Responses to AIR Data Requests – Nos. 12 through 42

Amended Application for Certification for HYDROGEN ENERGY CALIFORNIA (08-AFC-8A) Kern County, California

**RESPONSES TO DATA REQUESTS 12 THROUGH 42
FROM THE ASSOCIATION OF IRRITATED RESIDENTS (AIR)**

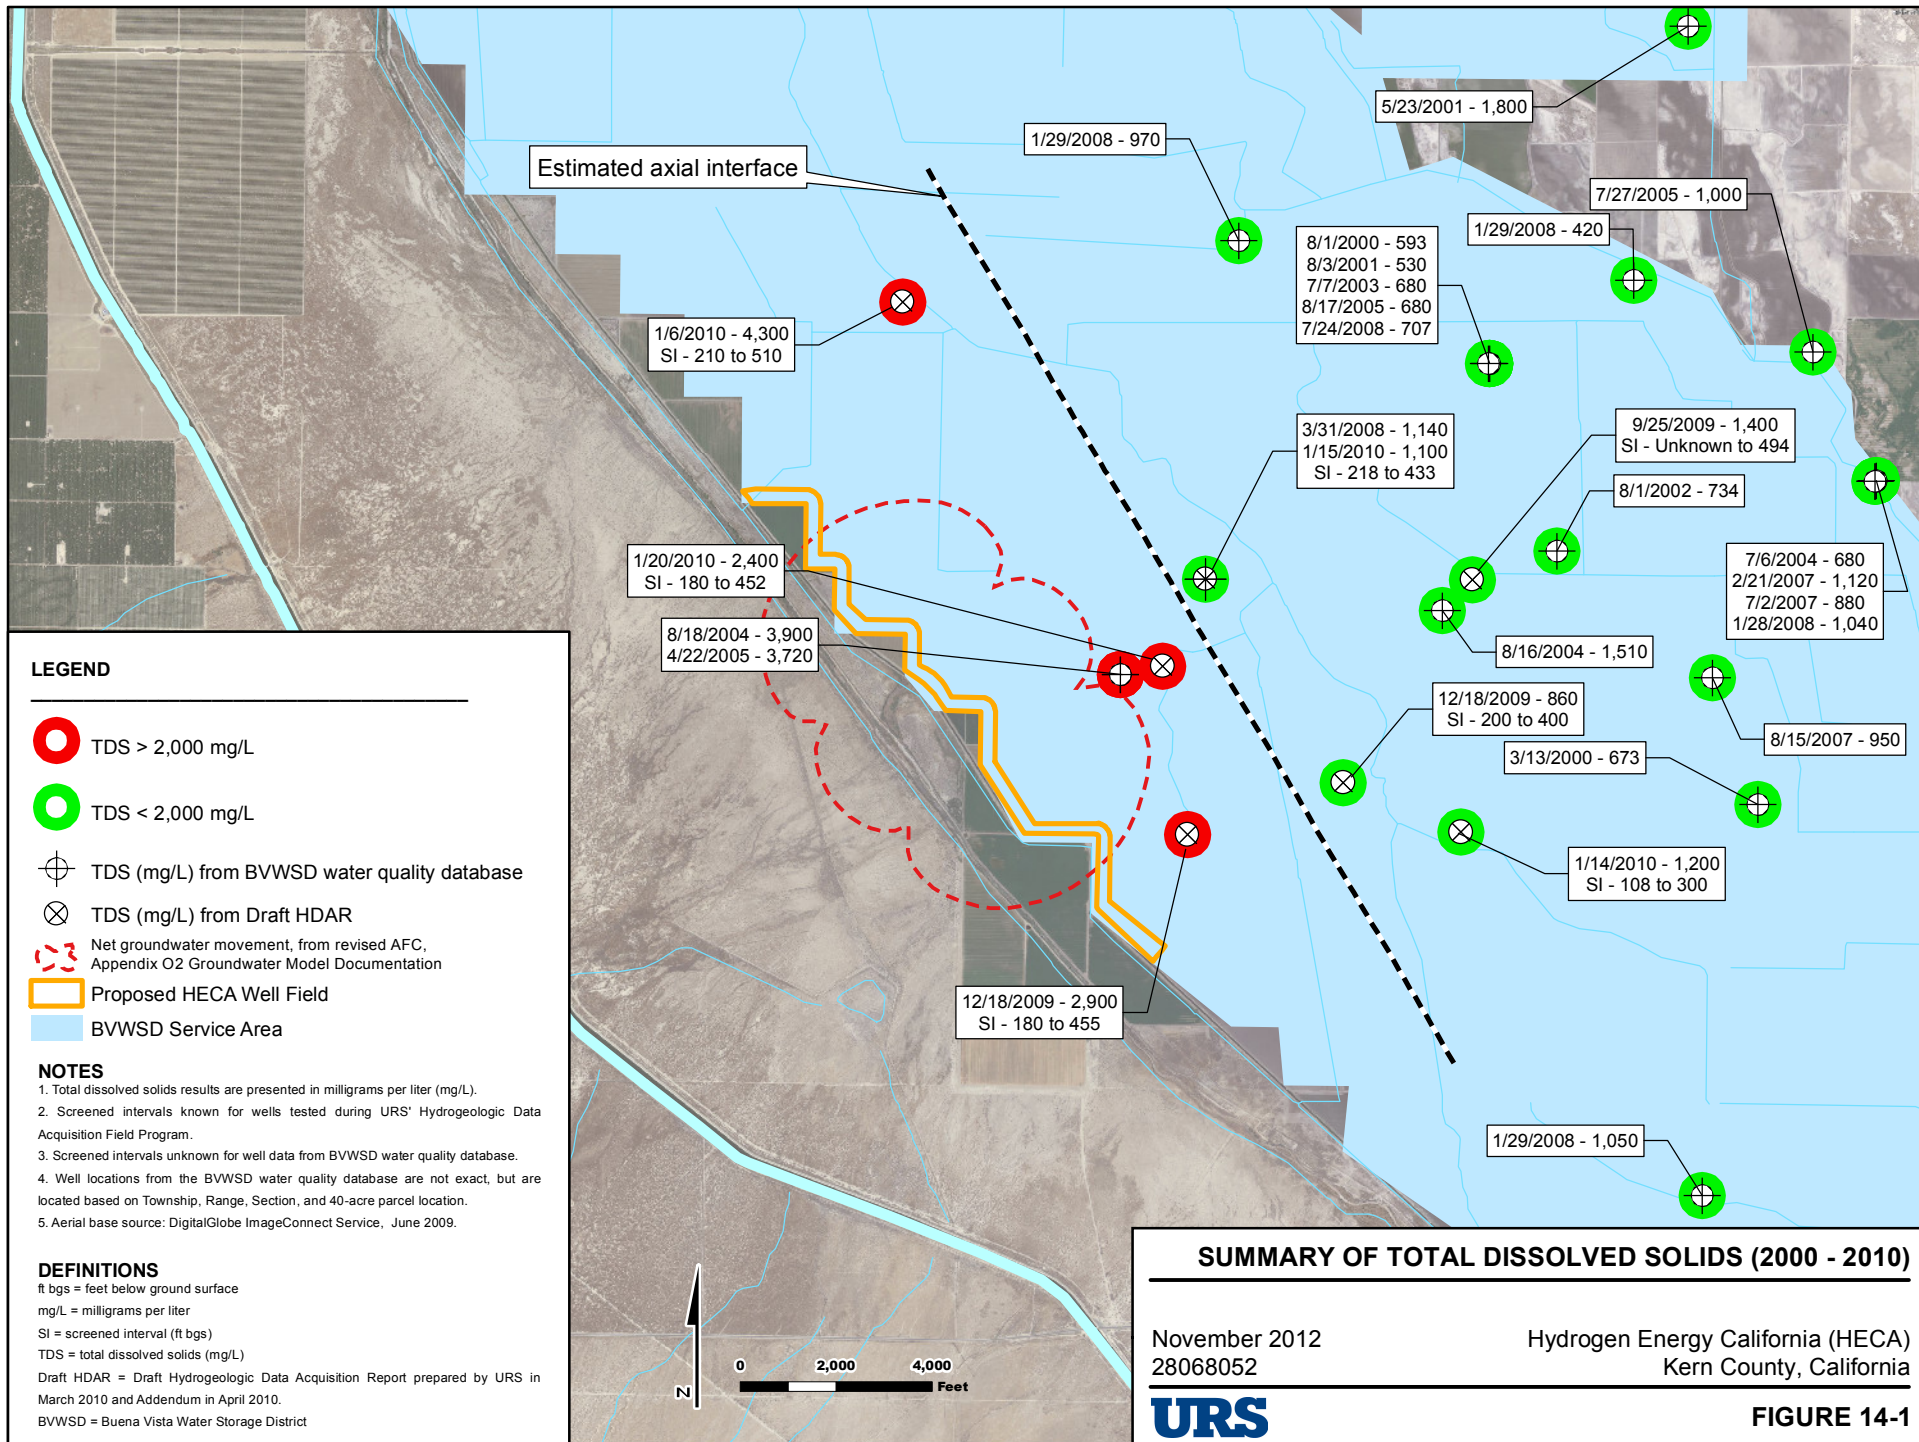
14. ***The so-called “brackish water” that will be pumped out of the ground for the plant water is said to be between 1000 and 2000 TDS. Water of this quality is usable irrigation water for several crops grown in the area, specifically pistachios and pomegranates. The total water to be pumped is stated to be approximately 7,500 acre-ft per year. This is obviously enough water of good enough quality to irrigate at least 2,500 acres of pistachios. The applicant states that pumping this water is a benefit to farmers in the Buena Vista Water District.***

Groundwater modeling, using data provided by BVWSD, has also been conducted to evaluate groundwater movement induced by Project pumping. TDS data presented on Figure 14-1, taken from BVWSD's water chemistry data base (collected from January 2000 to October 2007) and URS' Hydrogeologic Data Acquisition Field Program (conducted between September 2009 and January 2010), indicates that there is an axial interface approximately 0.8 mile east of the proposed BVWSD well field between good-chemistry (i.e., low TDS) groundwater (<2,000 mg/L TDS) and poor-chemistry (i.e., high TDS) groundwater (>2,000 mg/L TDS).

FIGURE 20-1 (1)

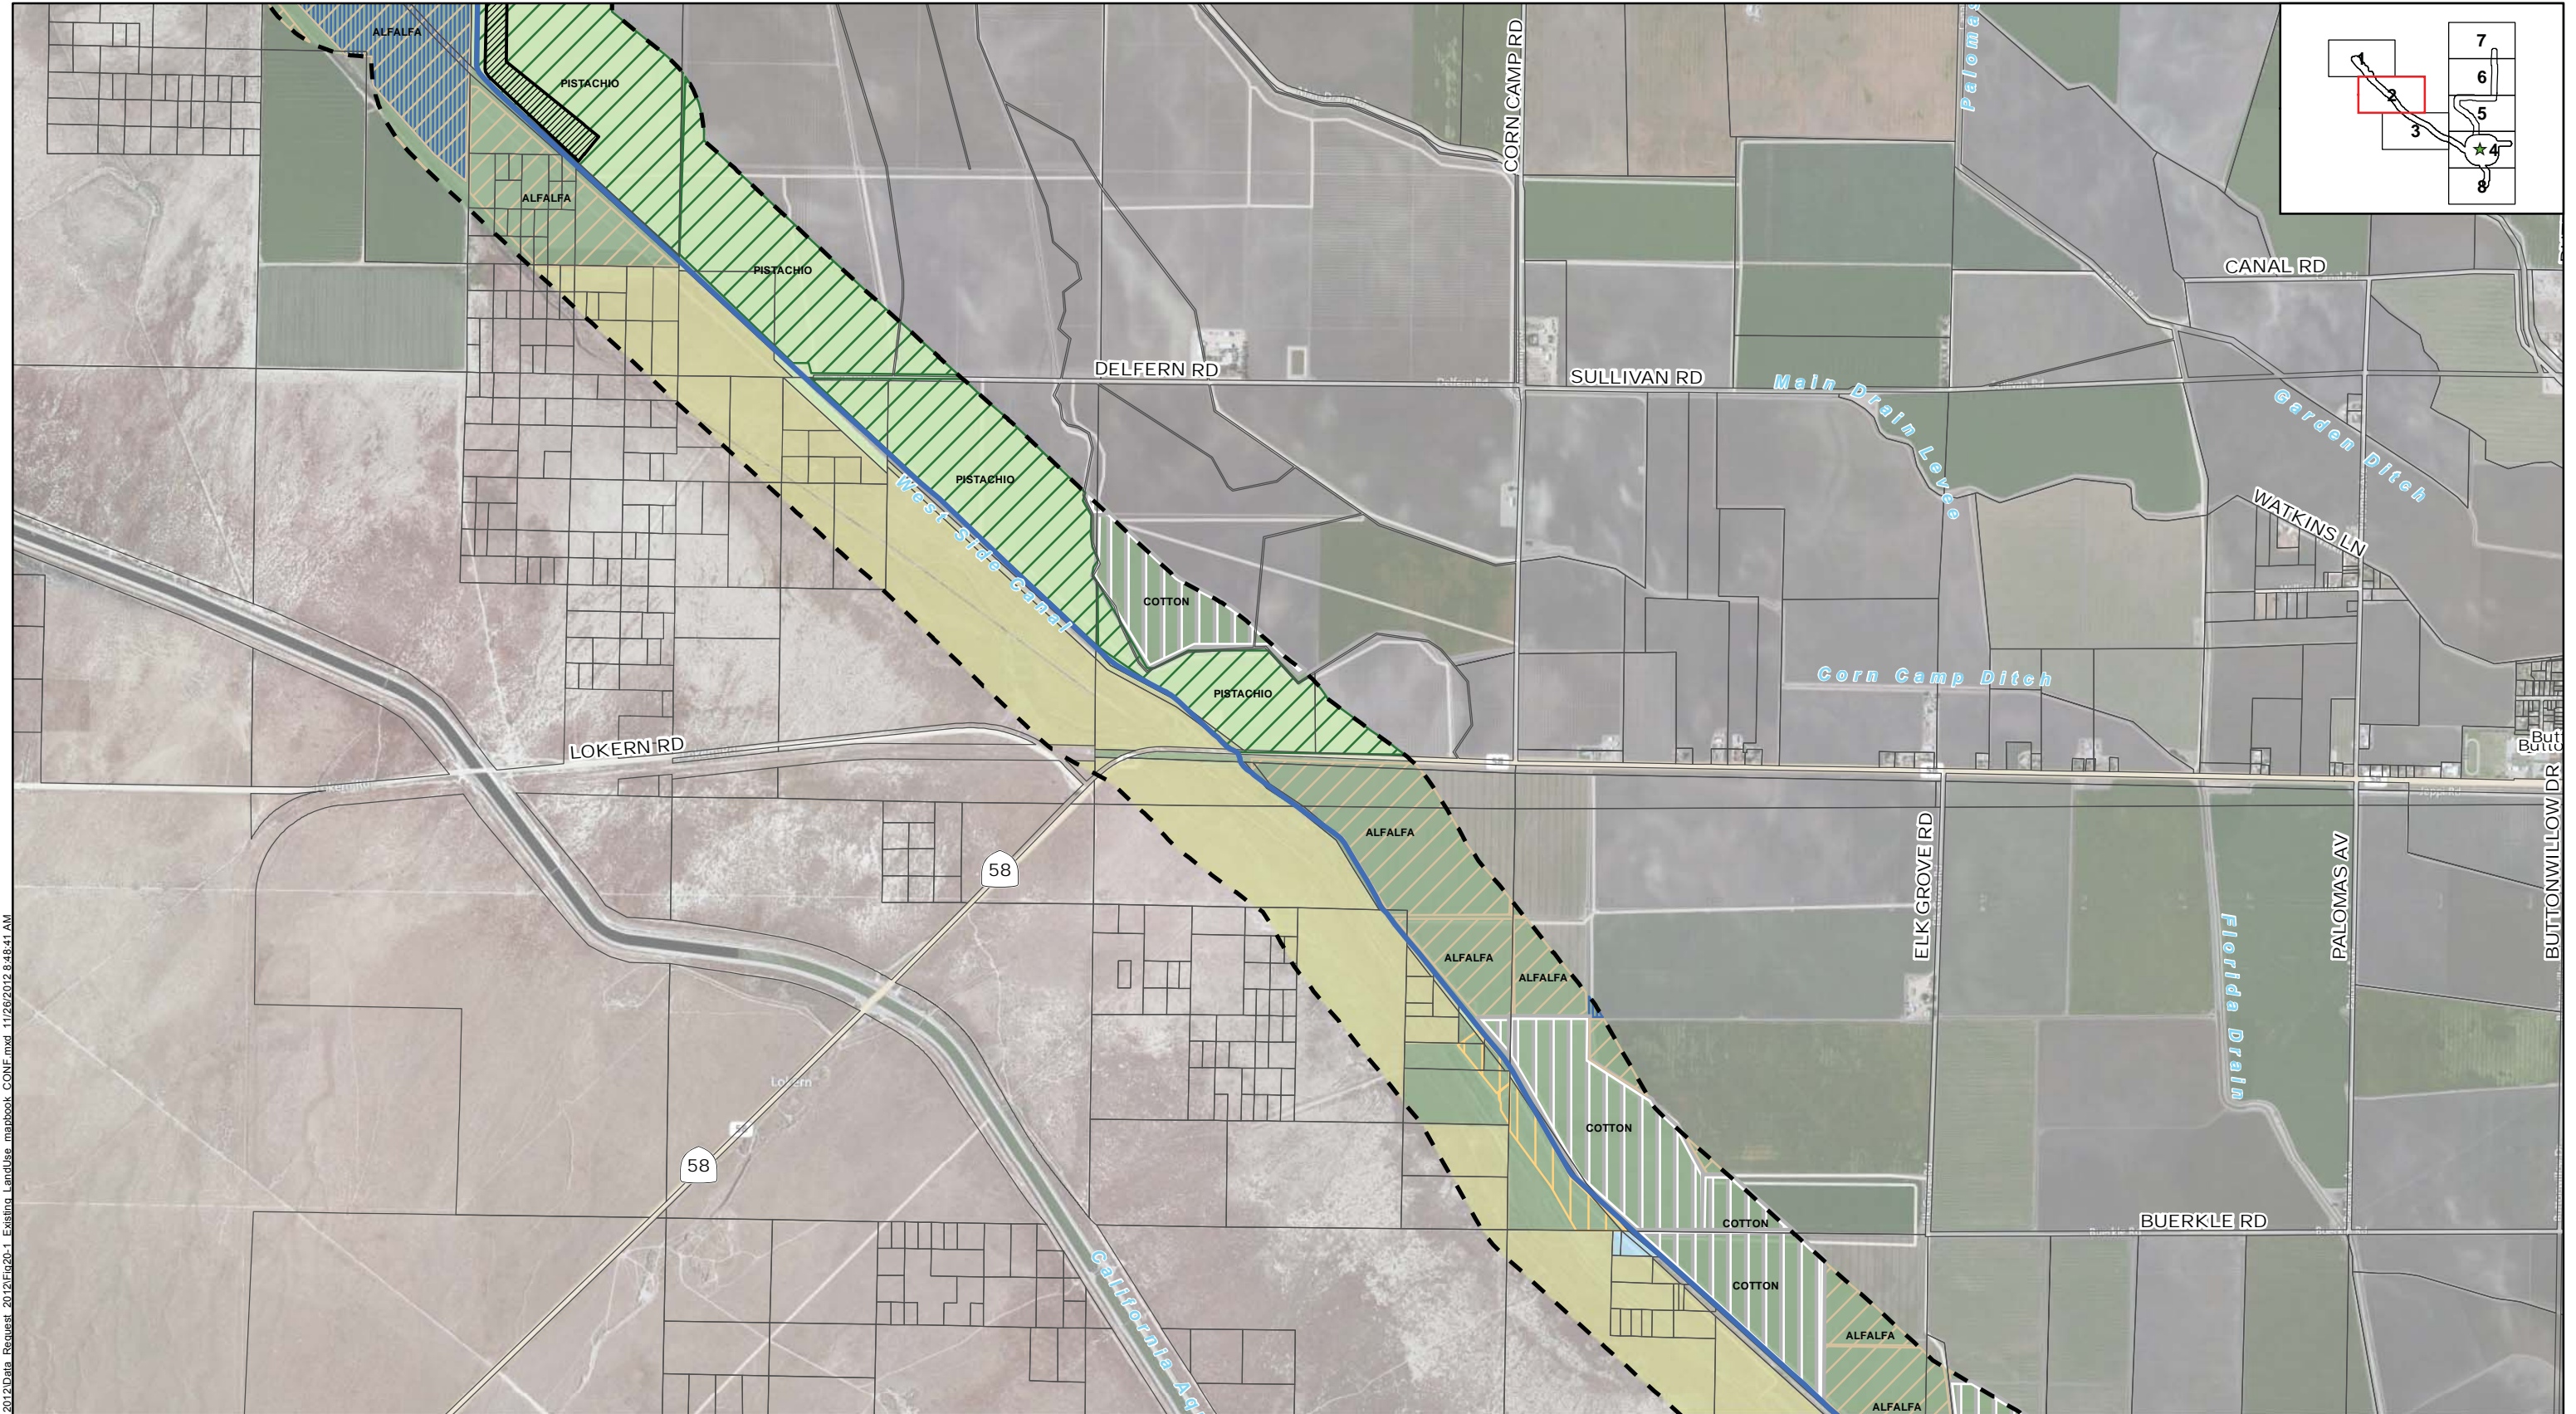
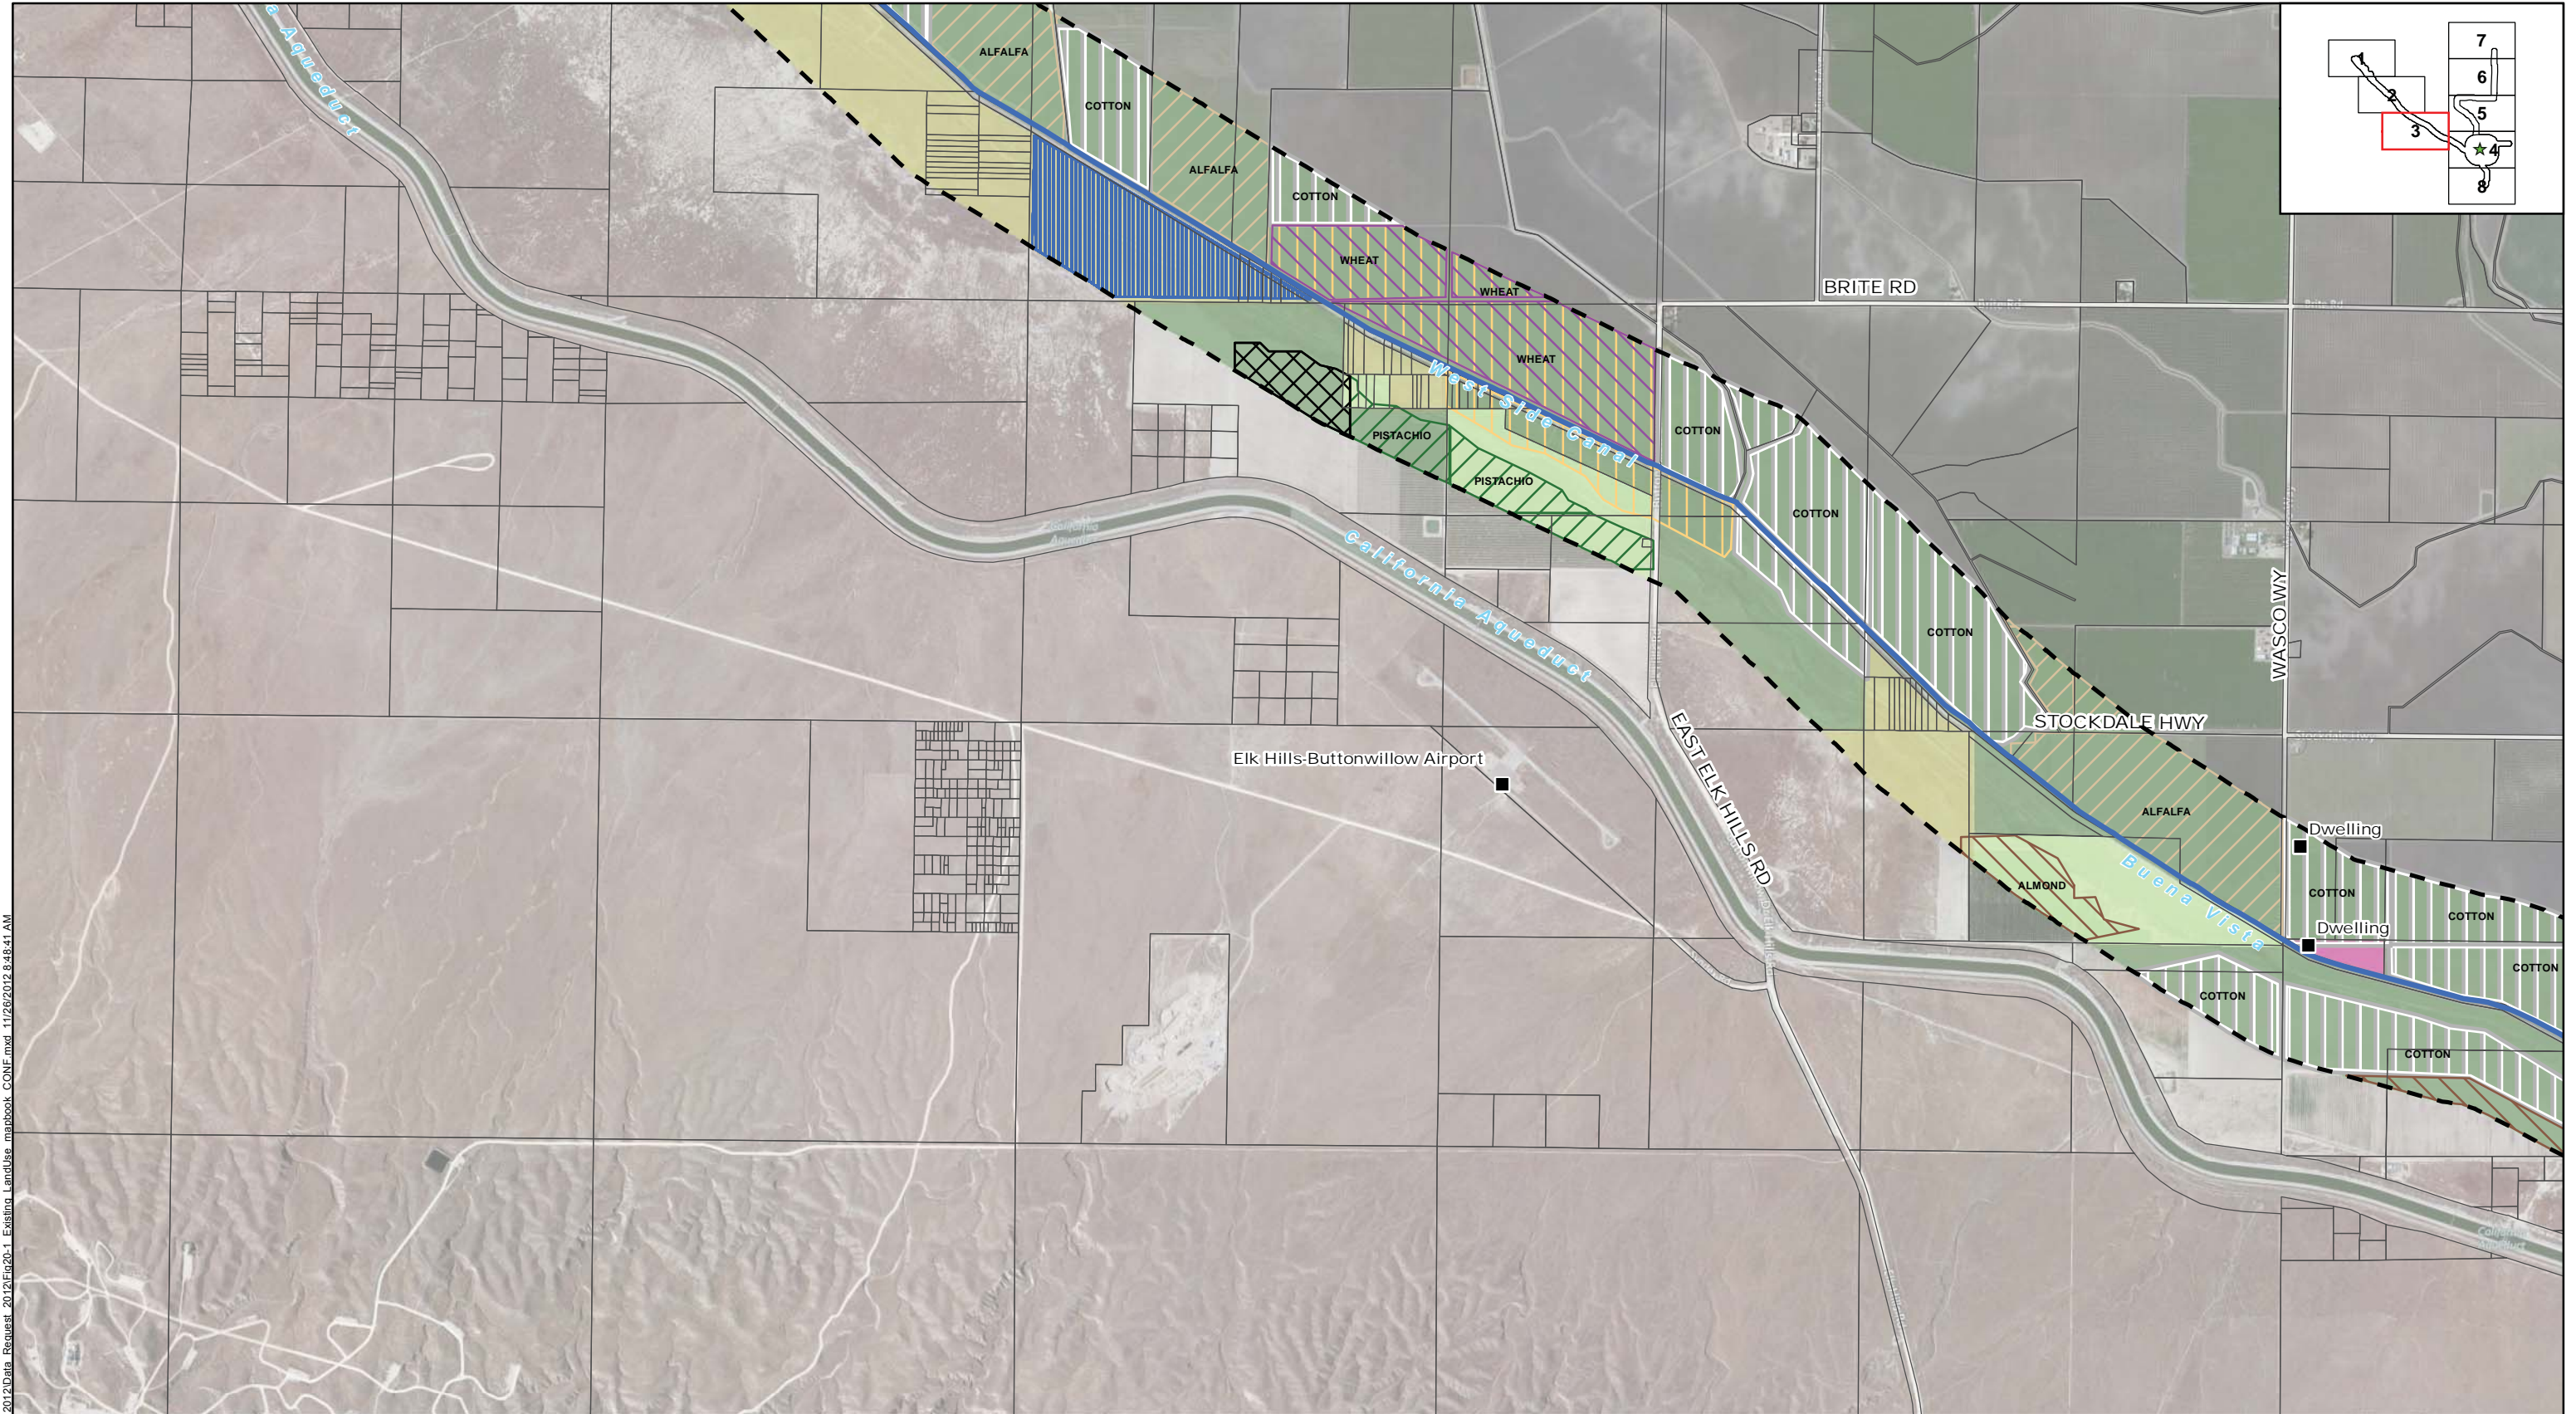
- (2) Where will the railroad spur be located? Please provide a map with details of the exact right of way needed so that each affected land owner will know exactly what is proposed on their respective properties.**

2. Figures showing the location of the railroad spur were previously provided to the CEC under confidential cover in May 2012. For reference and since the route is no longer confidential, the figures showing the location of the railroad spur and the land uses along the route are attached to this document as Figures 20-1 Sheets 1 through 8.
3. As indicated in the response to AIR Data Requests 1 and 2, as a private entity, HECA does not have the power of eminent domain. Thus, there are no plans to acquire any property or rights of way needed for the Project by eminent domain.
4. The exact route staff will travel to the Site will depend upon their point of origin but in general staff will travel from Stockdale Highway to Dairy Road and into the plant via the entrance off of Dairy Road. Alternatively, staff will travel via the truck route described in the response to Data Request 24 (3).
